Access Compliance Report

Public Rights-of-Way

(Pedestrian Signals)

Intersection ID: N/A	Main Street:	Cross Street: N/A	Location: N/A
ADA ID: CD392F6F7DDC	Signal Type: One Push Button-Non APS	Overall Compliance: No	Severity Score: BTN 1: N/A BTN 2: N/A No BTN: N/A
Codes/Mitigation Info/Possible Solution		Field Measurements/Component Compliance

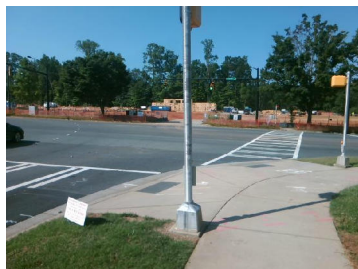
Surveyor Notes: TEXT HT 1/2

PROW/ADA: R410.6, TMUTCD 4e.08, R404.2, R406.2

Possible Solutions: Replace Signal Push Button With APS Button on New Post. Remove & Replace Sign.
